### ADDENDUM NO. 1

To the Drawings and Project Manual dated 16 June 2017

**TAS/ADA FIRE MARSHAL  
DEFERRED MAINTENANCE PROJECTS  
MIDWESTERN STATE  
UNIVERSITY**

Addendum Date: 2 August 2017

**HARDIN ADMIN BUILDING - FIRST FLOOR - AREA 1B**  
**ELECTRICAL DEMOLITION PLAN**  
SCALE: 1/8" = 1'-0"

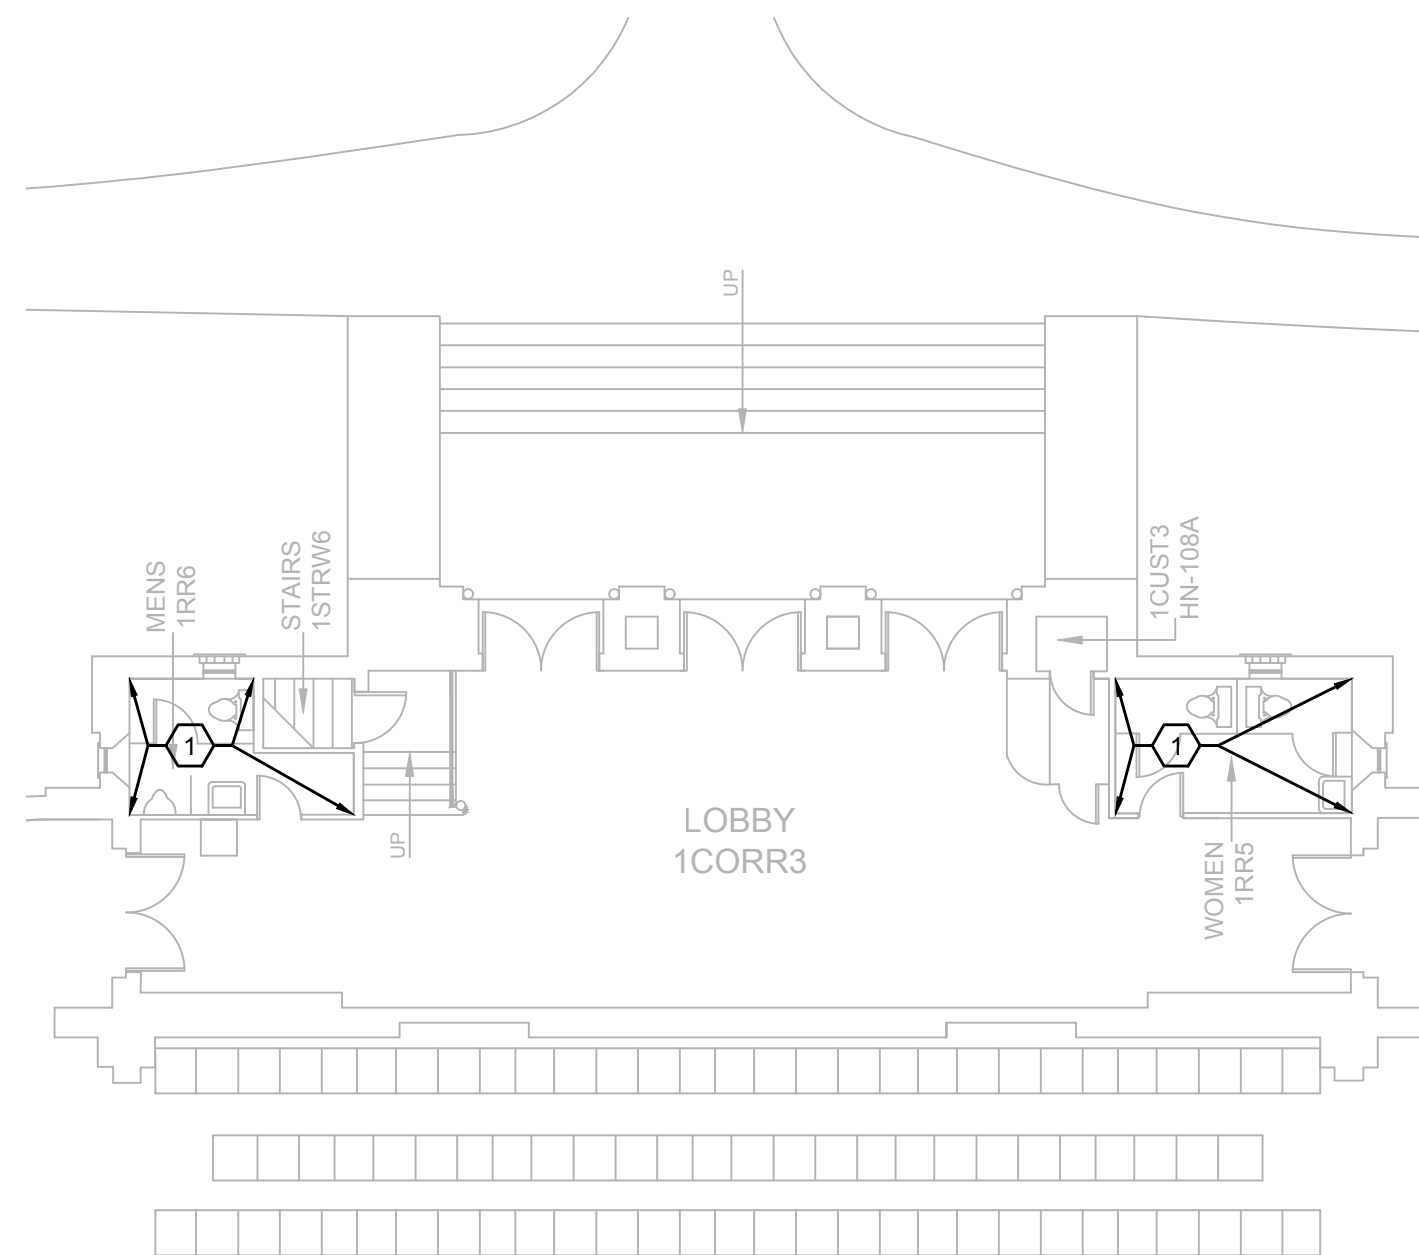
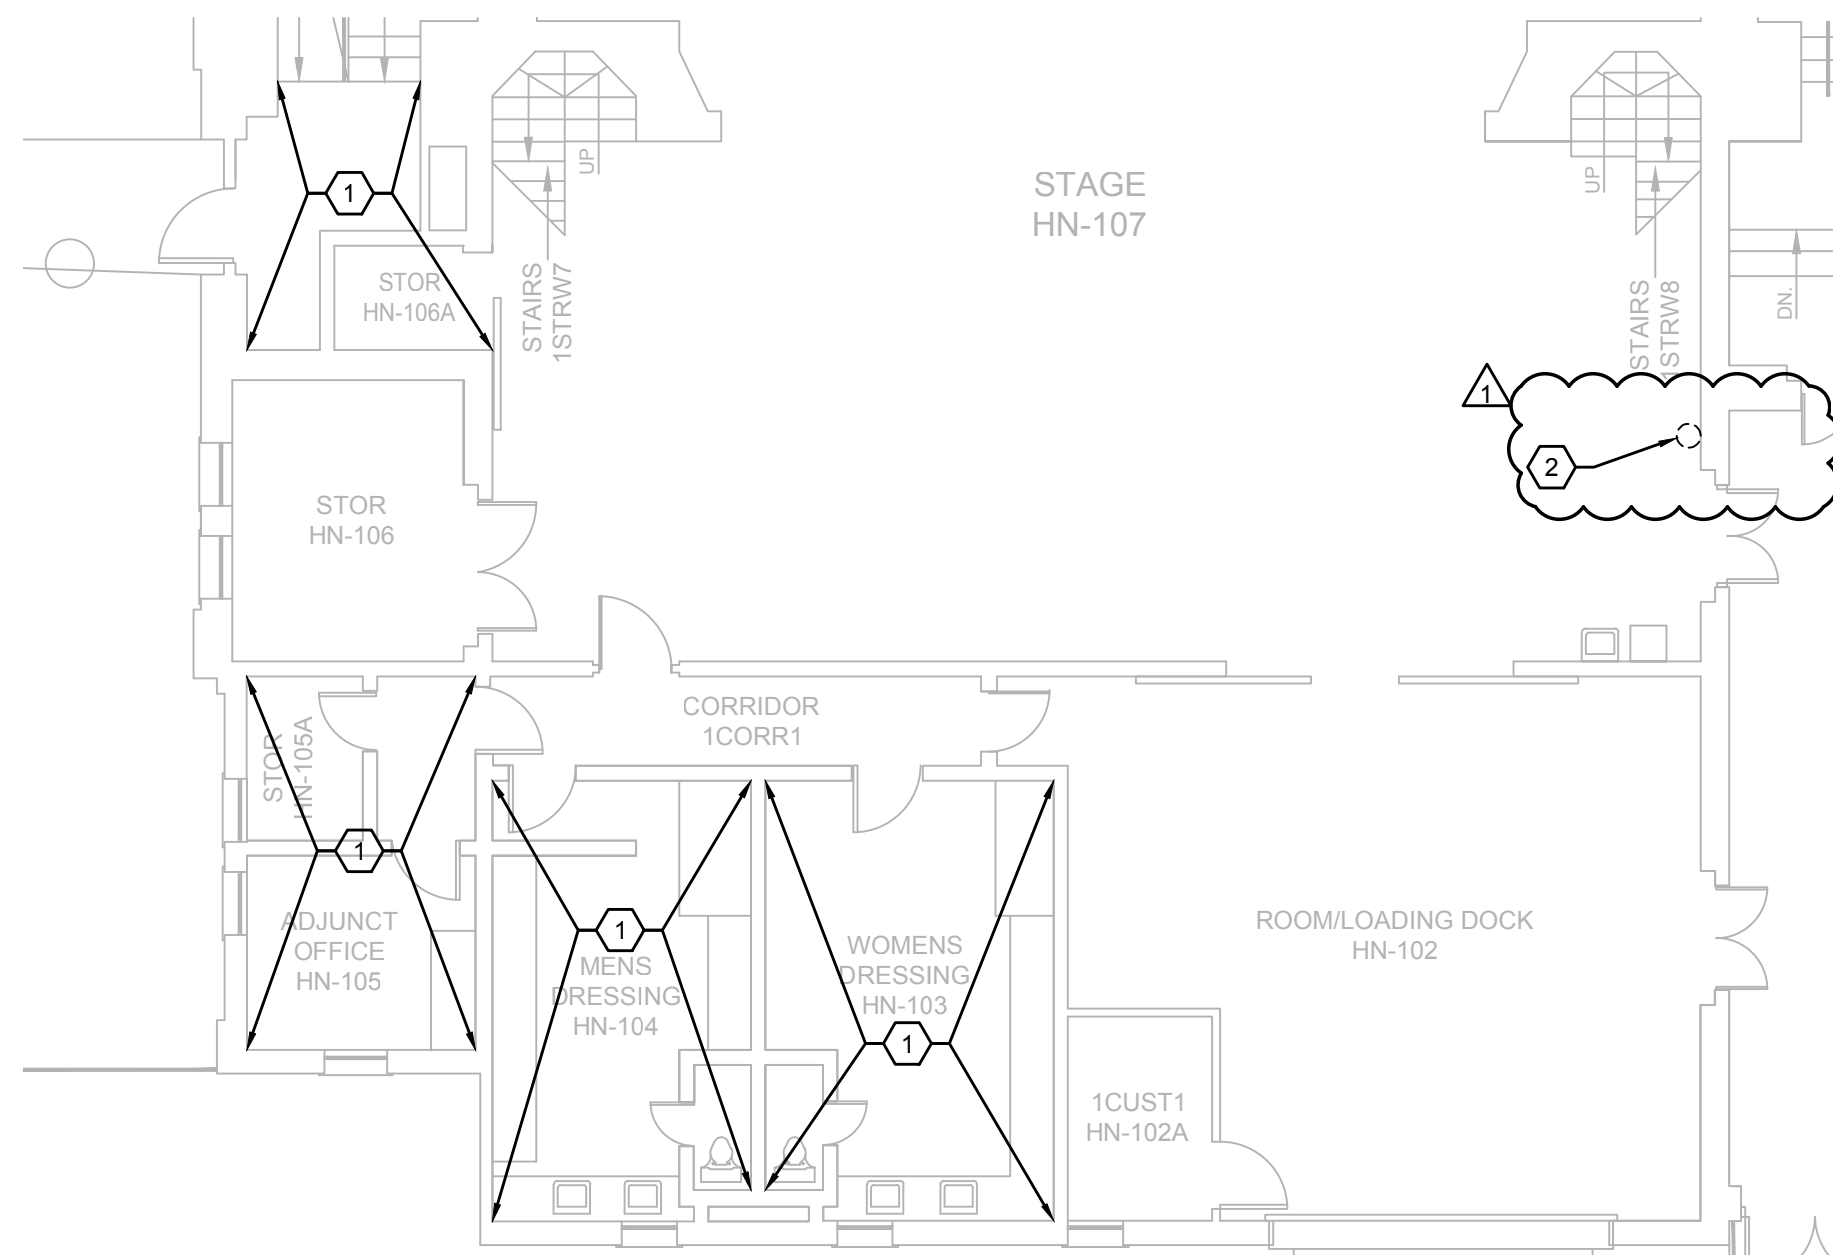
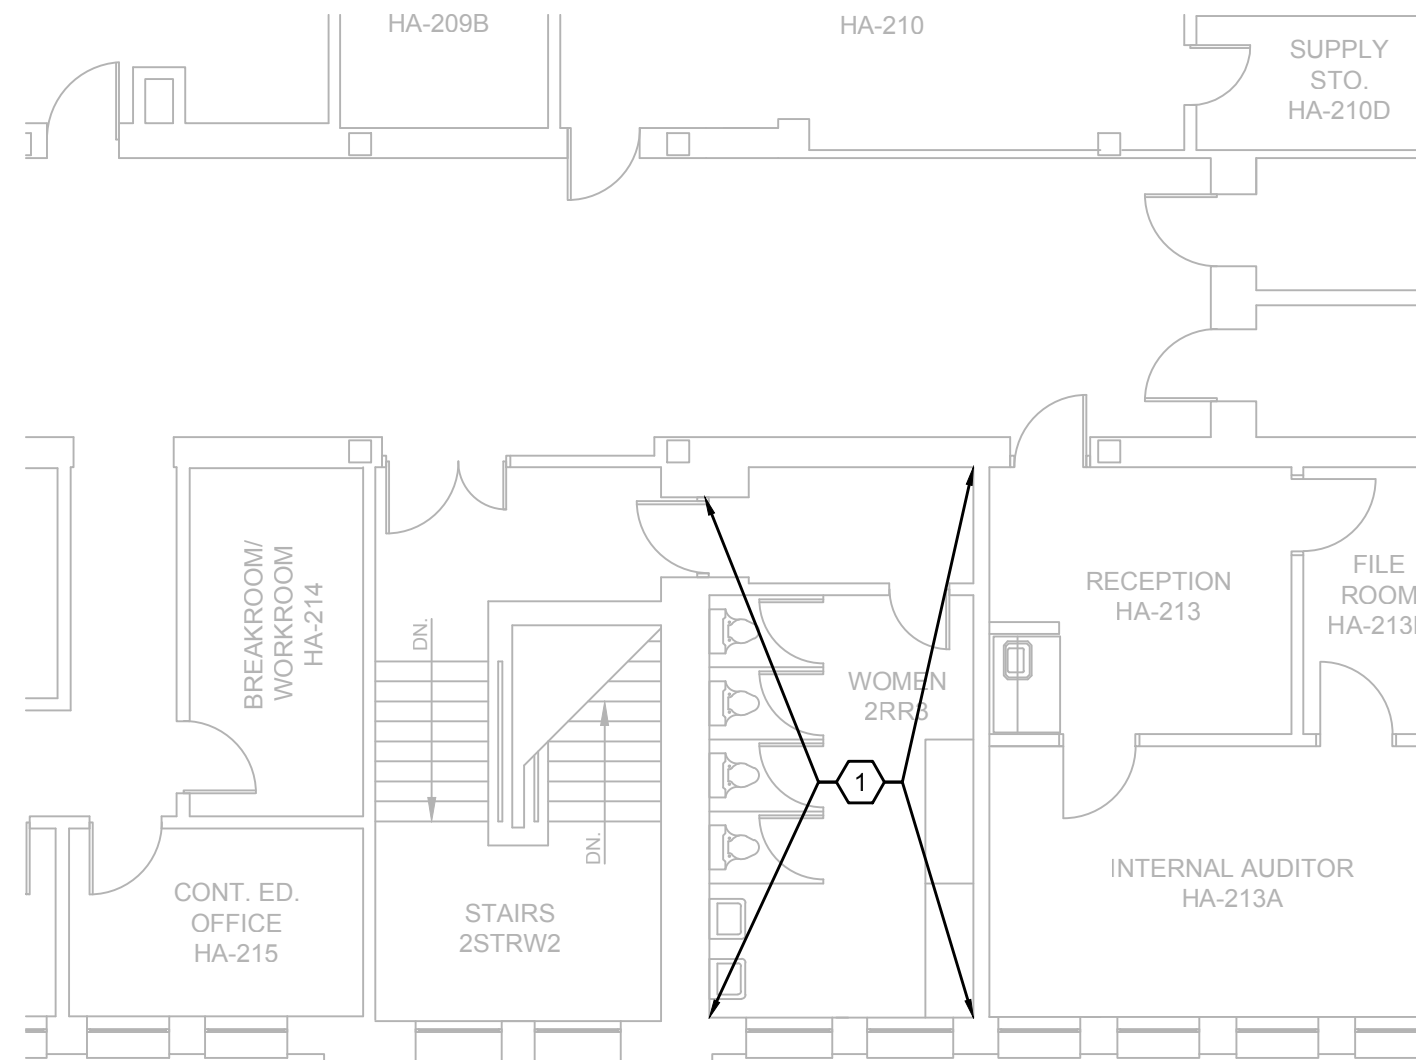
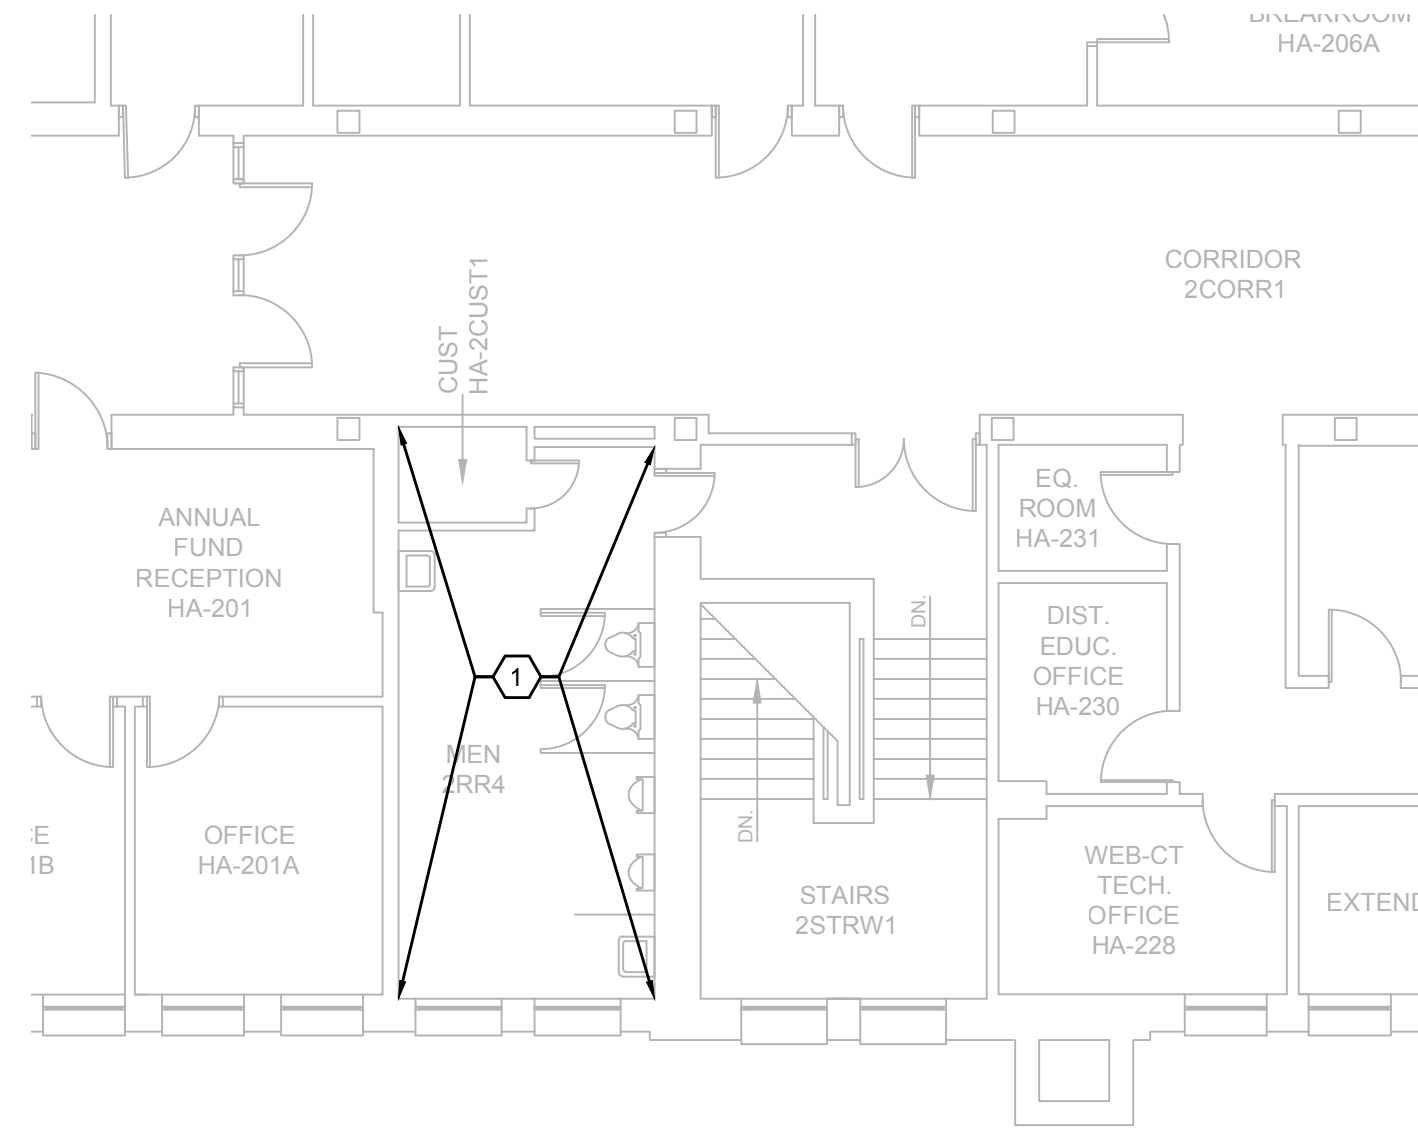
- c. Increased the M.C.B. and wiring to 150A for new Kitchen panel “K1”.
5. Sheet H-ED101 – Revised Drawing as follows:
  - a. Indicate that an existing empty conduit is to be cut.
